802.3cb Comments 272 and 273 Resolutions

Introduction

2.5G Insertion Loss Equation and Plot

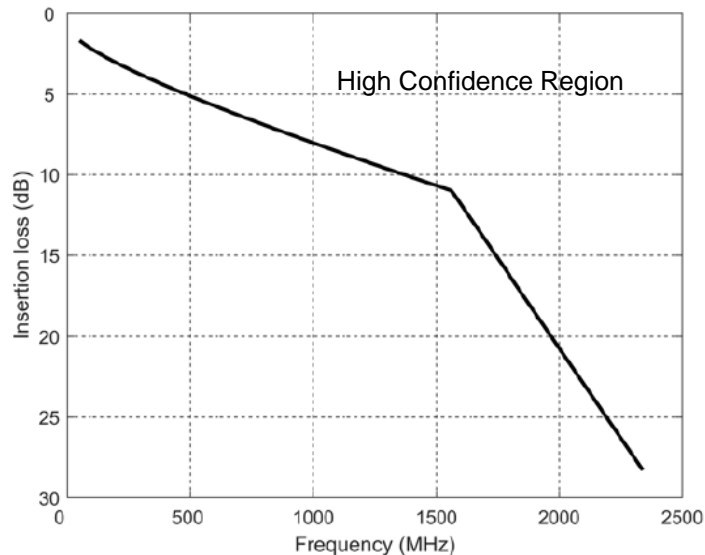
- Note:

- $0.05 = f_{\min}$
- $1.5625 = f_2$
- This implies the editor should change the following frequencies shown in the equation below:
 - **0.5 to f_{\min}**
 - **1.5625 to f_2**
 - **2.34375 to $1.5 \cdot f_2$**

$$Insertion_loss(f) \leq \left\{ \begin{array}{ll} 0.668 + 3.755\sqrt{f} + 3.608f & 0.05 \leq f < 1.5625 \\ -23.753 + 22.242f & 1.5625 \leq f < 2.34375 \end{array} \right\} \text{ (dB)}$$

where
 f is the frequency in GHz

5G Insertion Loss Equation and Plot

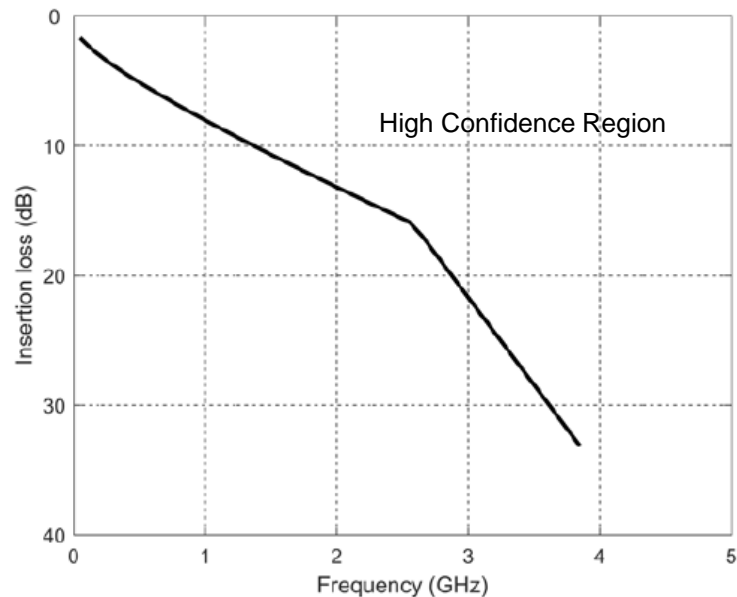
- Note:

- $0.05 = f_{\min}$
- $2.578125 = f_2$
- This implies the editor should change the following frequencies shown in the equation below:
 - **0.5 to f_{\min}**
 - **2.578125 to f_2**
 - **3.8671875 to $1.5 \cdot f_2$**

$$Insertion_loss(f) \leq \left\{ \begin{array}{ll} 0.668 + 3.755\sqrt{f} + 3.608f & 0.05 \leq f < 2.578125 \\ -18.753 + 13.48f & 2.578125 \leq f < 3.8671875 \end{array} \right\} \text{ (dB)}$$

where f is the frequency in GHz, and
